telegraph canyon creek City of Chula Vista

Detailed Project Report for
Flood Control
and
Final Environmental
Impact Statement

July 1983

Volume II

**URBANIZATION - LAND USE
 1990 GENERAL PLAN**

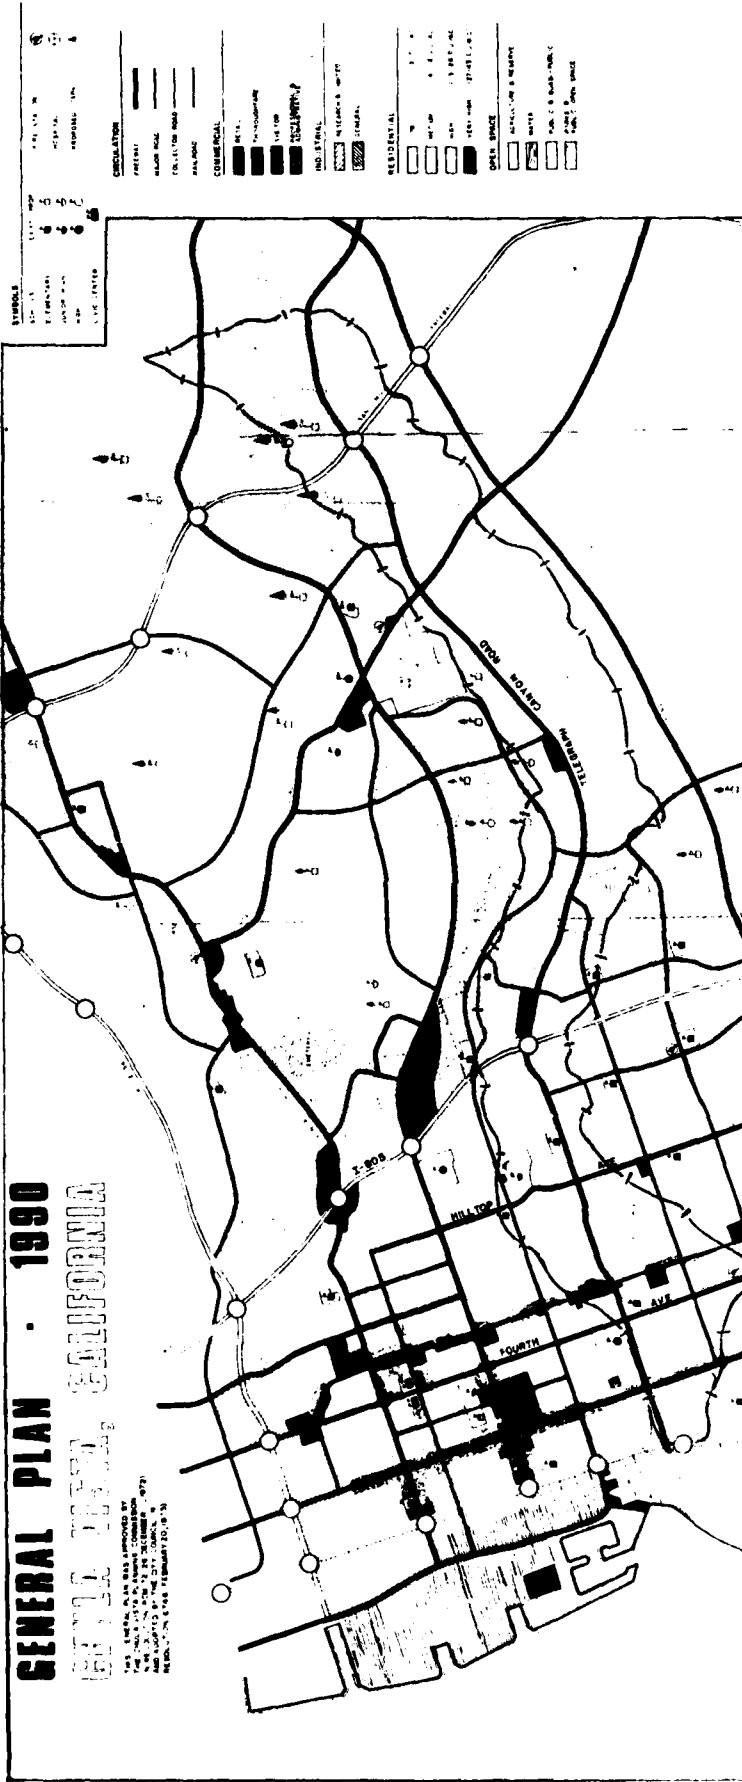
Page 3, No. 1. The area downstream from Interstate 805 is nearly fully urbanized but lands above Interstate 805 are presently mainly agricultural. Plate 8 in appendix E (Urbanization--Land Use; 1990 General Plan) indicates partial urbanization of the project drainage area above Interstate 805 by 1990. Runoff from the primarily urban portions of the drainage area does not carry much sediment, and as urbanization extends upstream from Interstate 805, the percentage of "clean" runoff, that is runoff lacking in sediments, should increase. As noted in paragraph 4.11 in the DEIS, no significant changes in sediment deposition or turbidity will be caused by the proposed action. This applies with the project modification as well.
